January 25, 2021  
**VIA E-MAIL**

Re: ***375 Main Street – Site Plan Approval  
Section 108.03, Block 1, Lot 75***

As you know, we represent NY Fuel Distributors, LLC (the “Applicant”) in connection with the above-referenced property (the “Subject Property”). We respectfully submit herewith the following amended plans and supplemental information for your consideration at your upcoming meeting on February 8, 2021.

PROJECT:  
**PROPOSED SITE IMPROVEMENTS TO SHELL GAS STATION**  
 375 MAIN STREET  
 ARMONK, NY

**PROPOSED SITE PLAN**  
 SCALE: 1" = 10 FEET

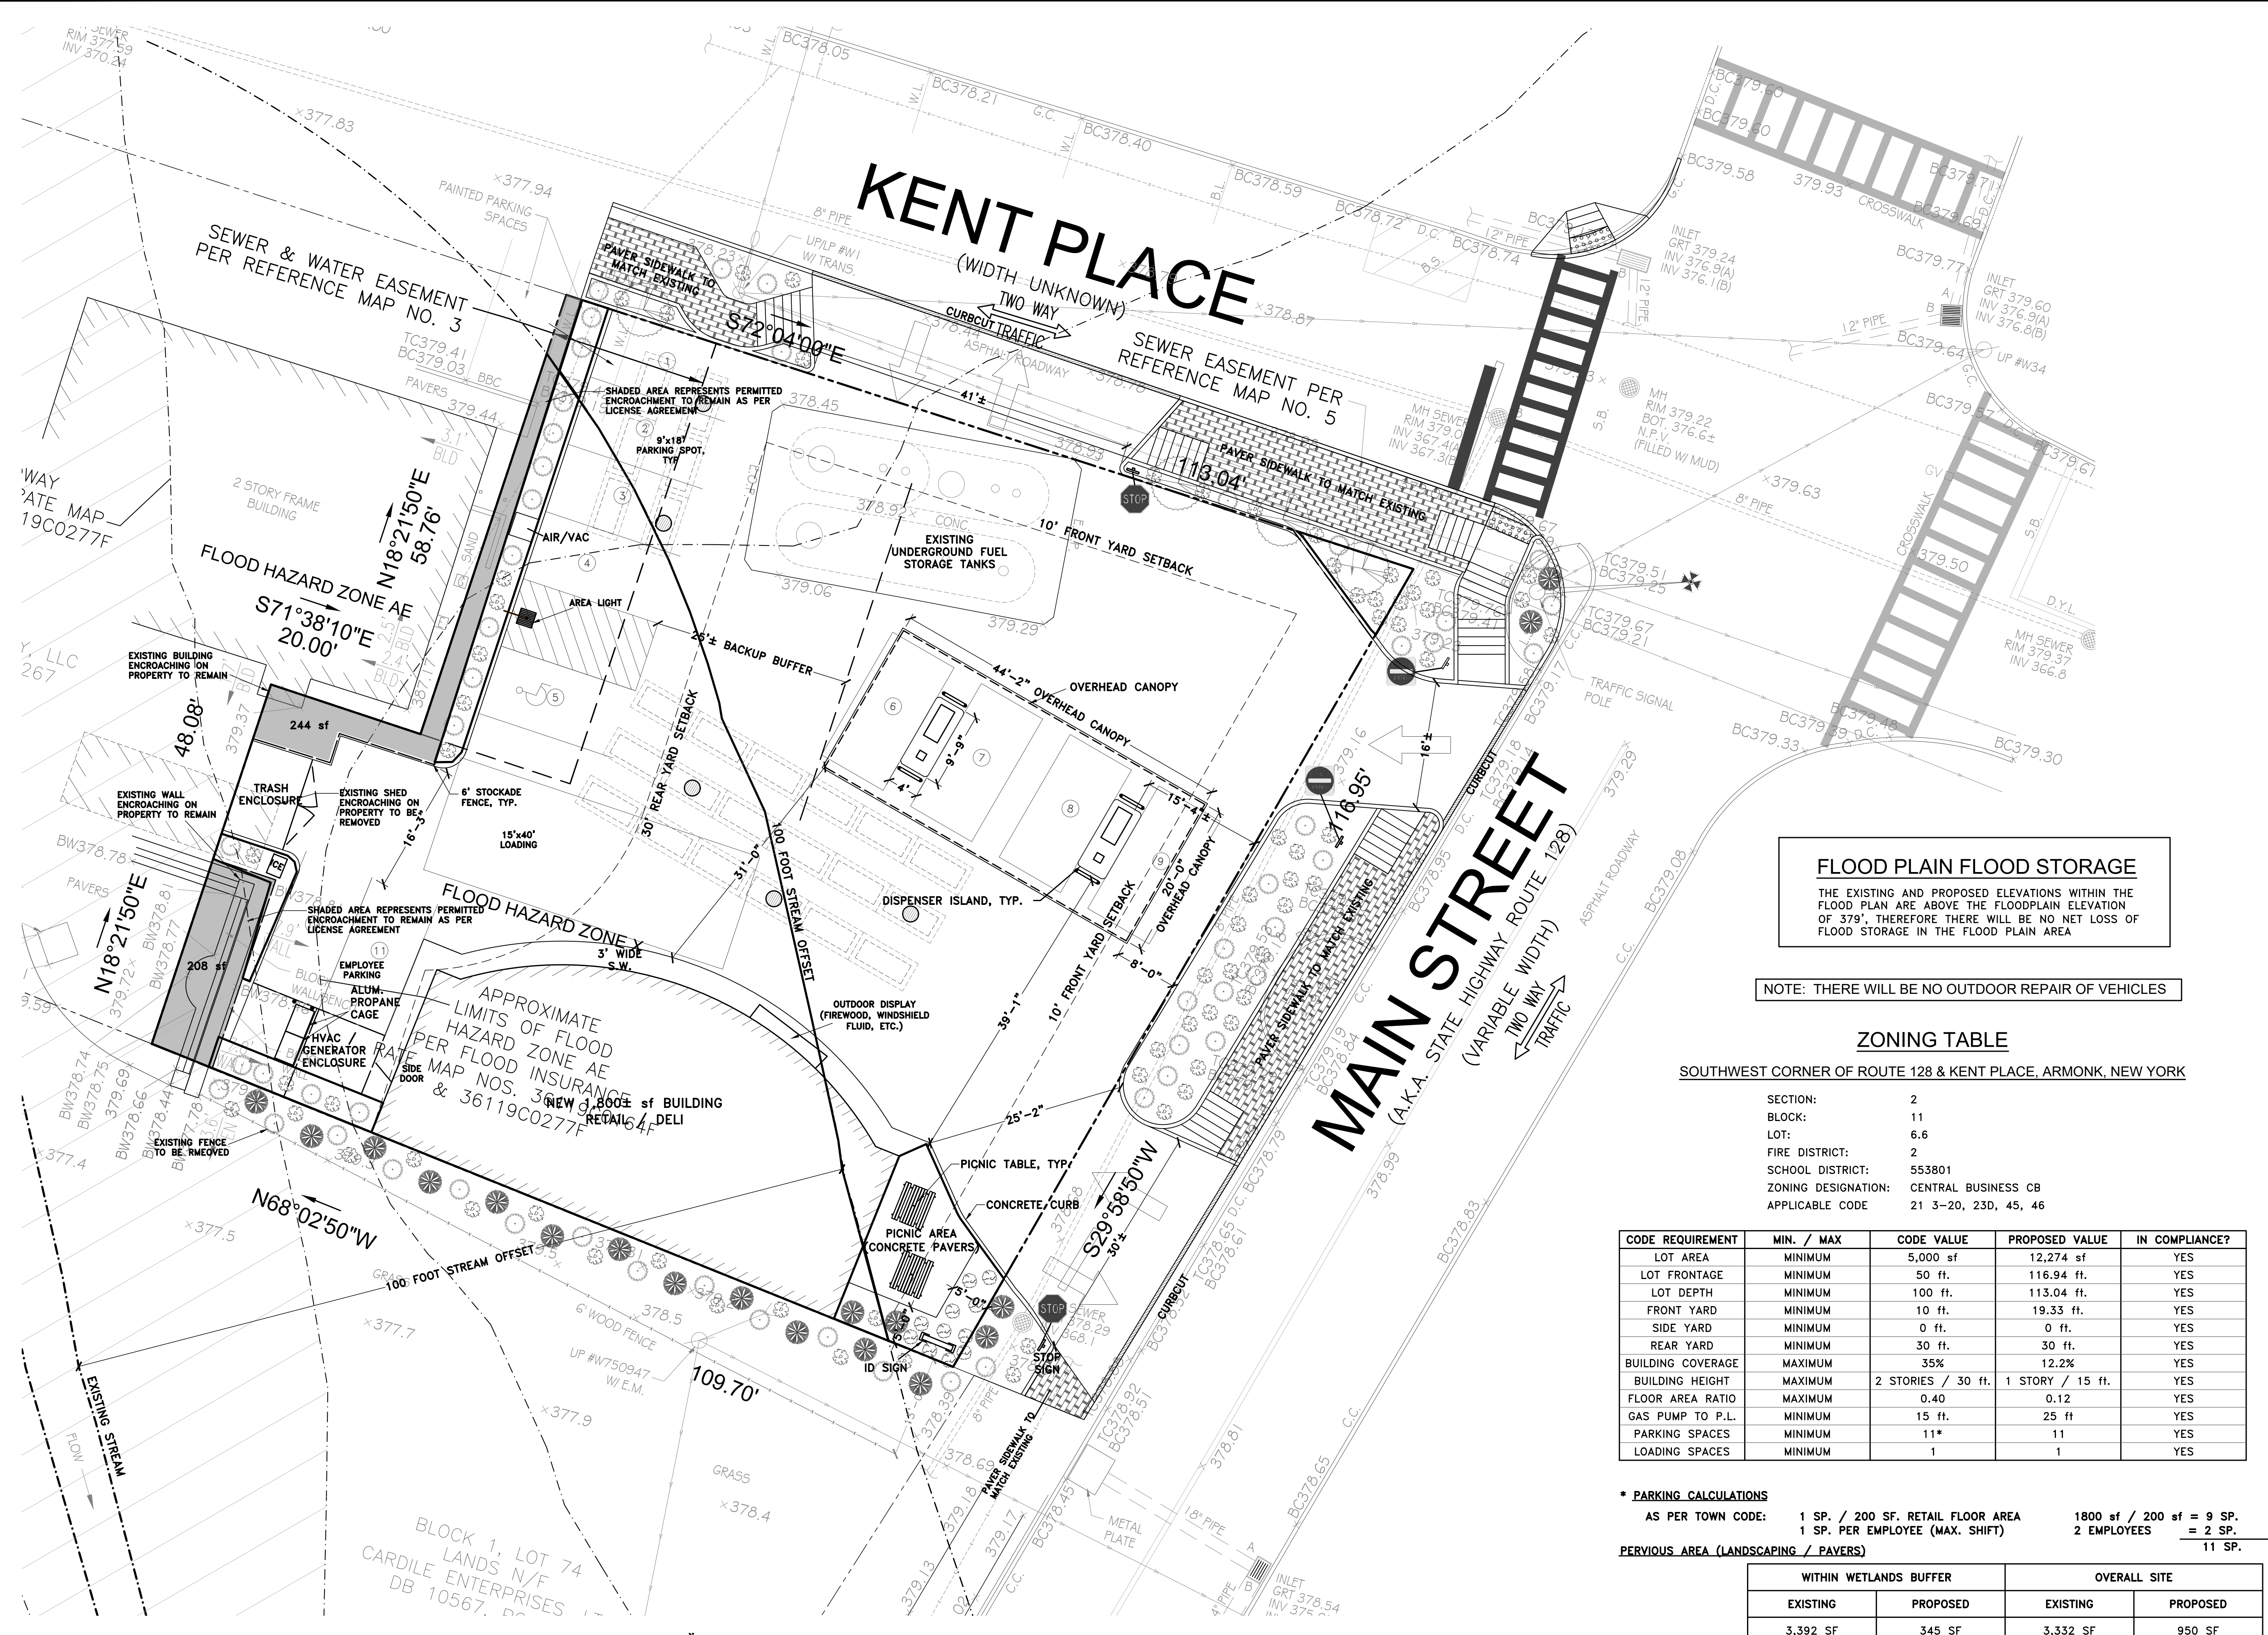
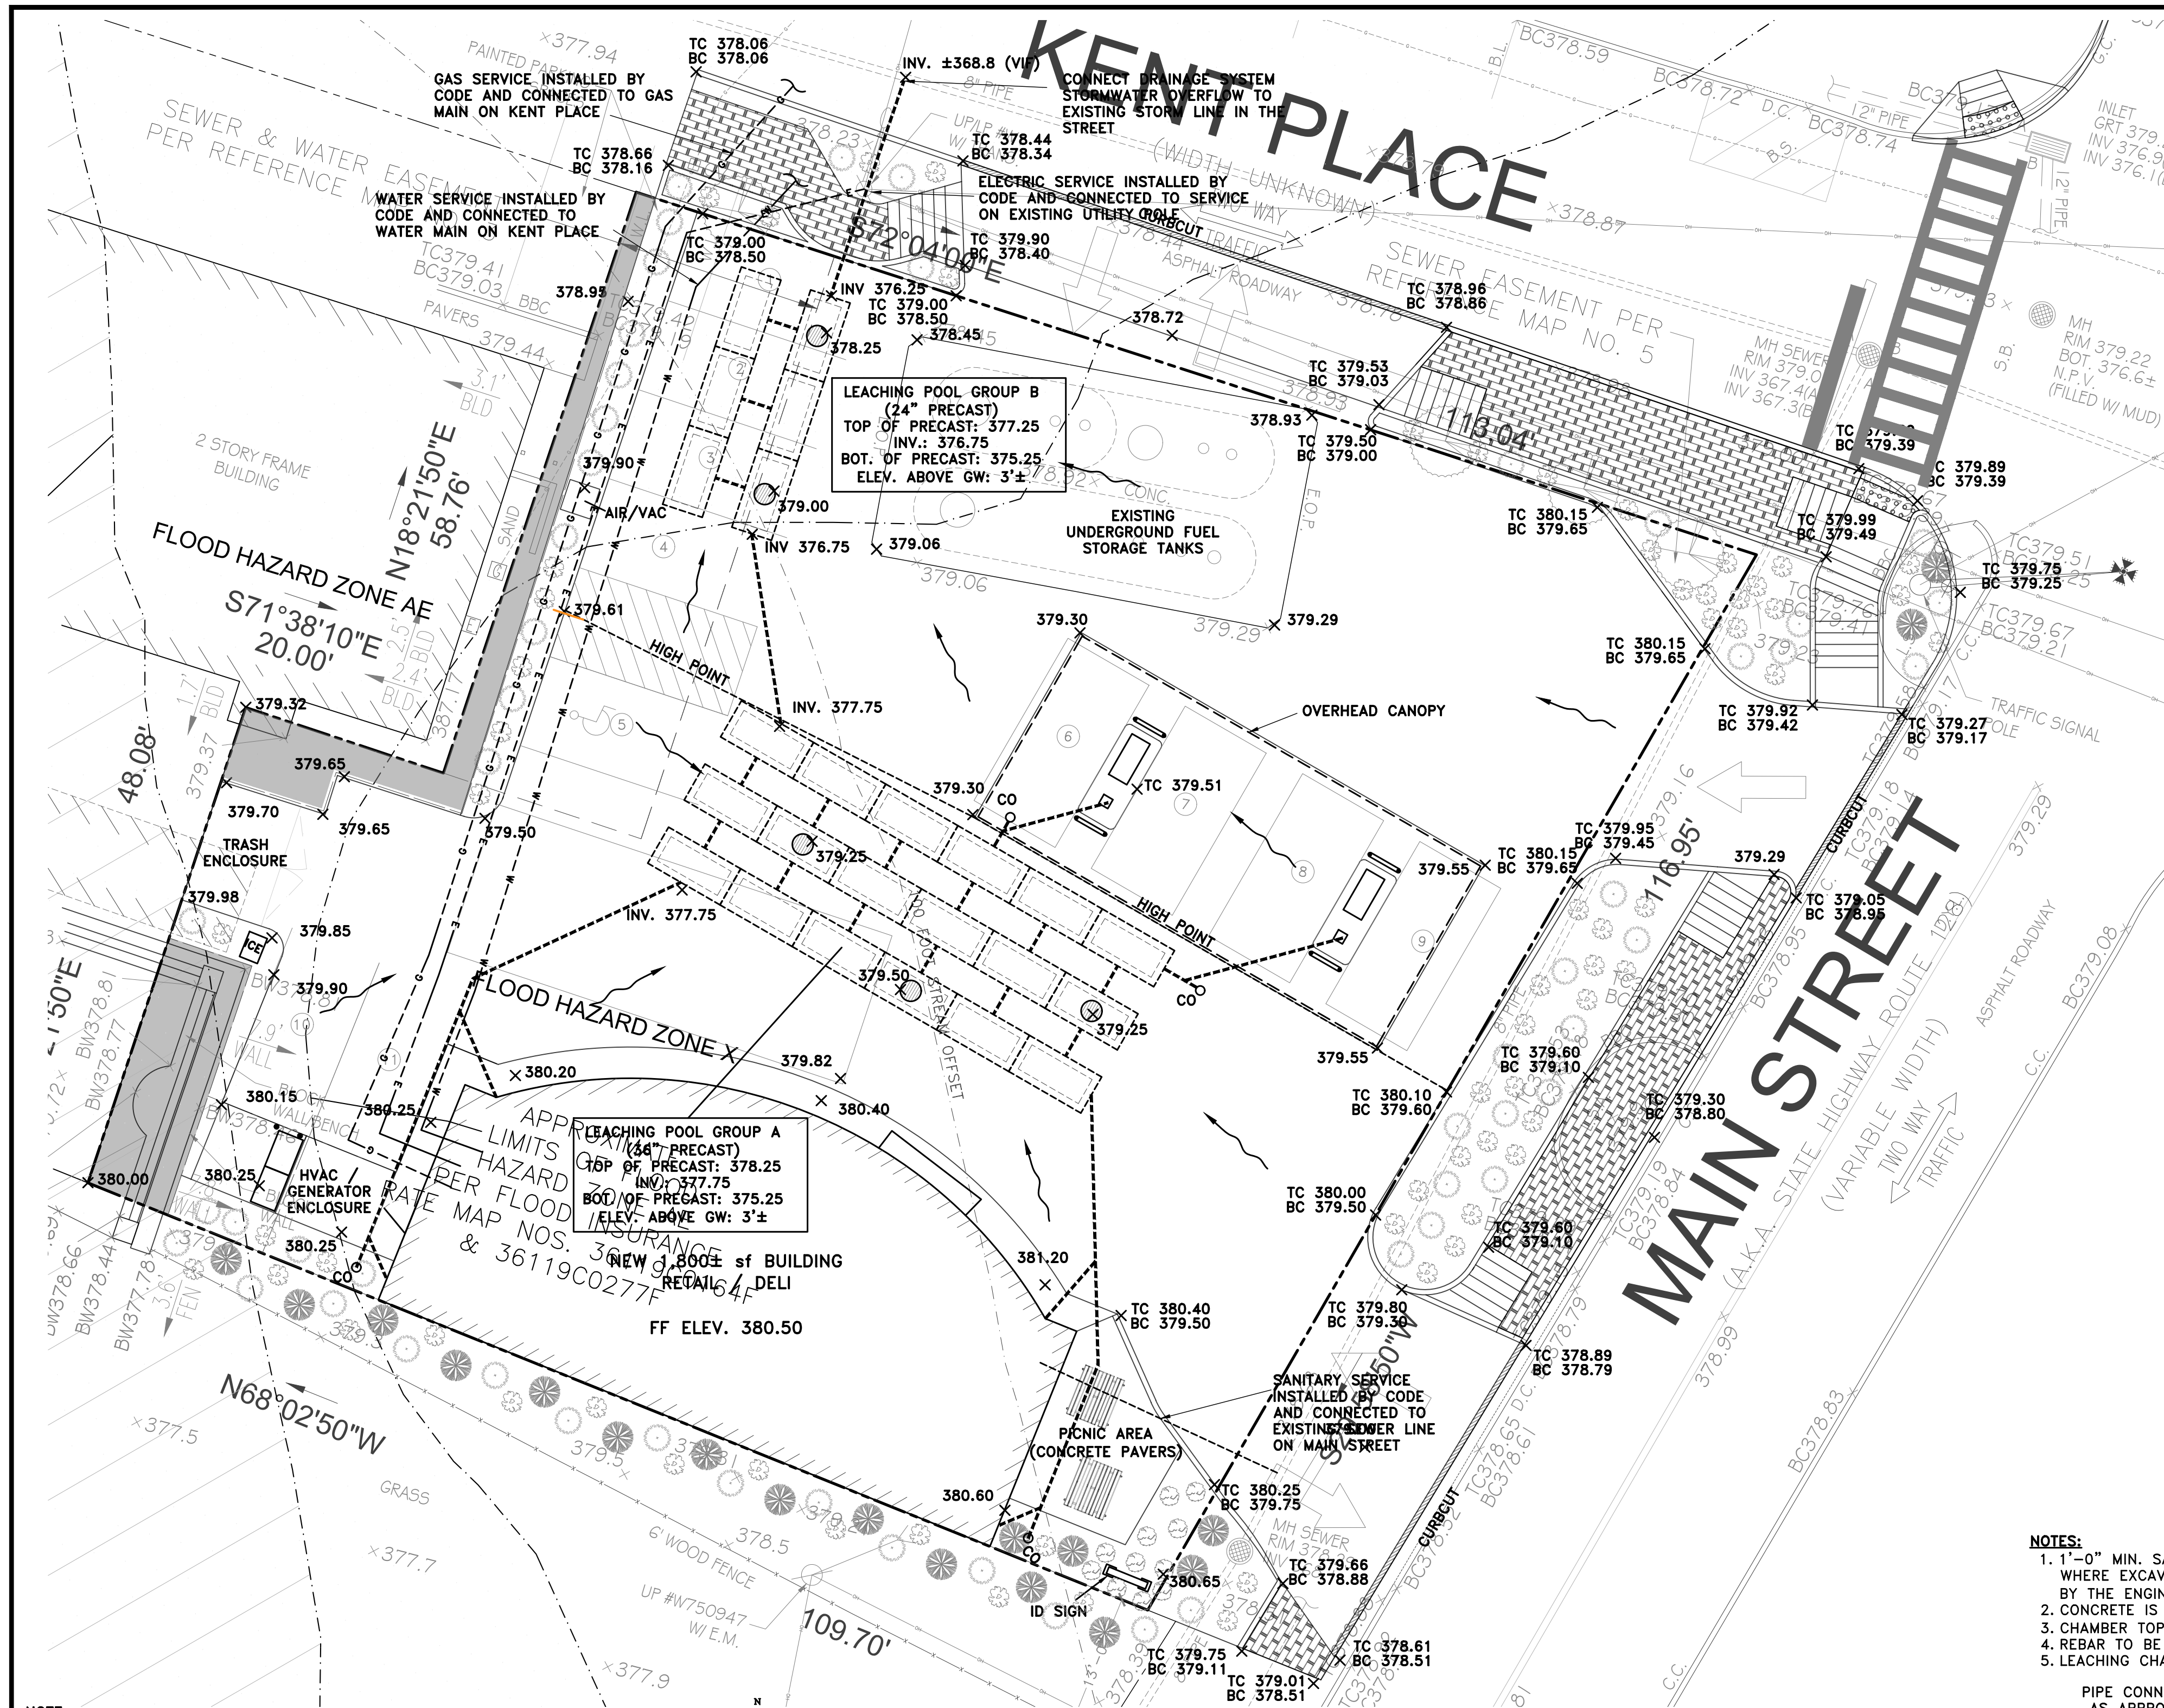
15. *The site plan depicts a new paved picnic area. While this feature can be a nice amenity, it is strongly recommended that the surface be revised. The Applicant should think about a grass picnic area or a paver patio. In addition, this area should be improved with attractive street furniture, which should be depicted on the site plan as this area will be a highly visible feature in the Armonk Hamlet.*

- a. The site plan has been revised to depict two picnic tables in the area and the Applicant is proposing to surface the area with concrete pavers.
16. *The proposed air pump and vacuum cleaner are located in off street parking spaces. The Planning Board at the May 28, 2020 meeting directed the Applicant to remove the vacuum from the site plan. The Applicant should also give consideration to relocating the air pump to a location that is less impactful to the adjacent restaurant.*

6. *As previously requested, the Site Plan has been revised to correctly illustrate the required 30 feet rear yard to demonstrate that the proposed building meets the required setback. However, Town Zoning Code requires that gasoline pumps not be located nearer than 15 feet to a lot*

*line. The site plan should be dimensioned to demonstrate compliance with this, it appears the 15 feet is not provided.*

- a. The setback to the fuel pumps is now shown on the site plan and is in excess of 15 feet.
7. *As previously noted, the plan provides the required eleven (11) off-street parking spaces by including the four (4) vehicle fueling positions provided at the dispensers. The Planning Board should discuss whether this is appropriate, otherwise an area variance will be required.*
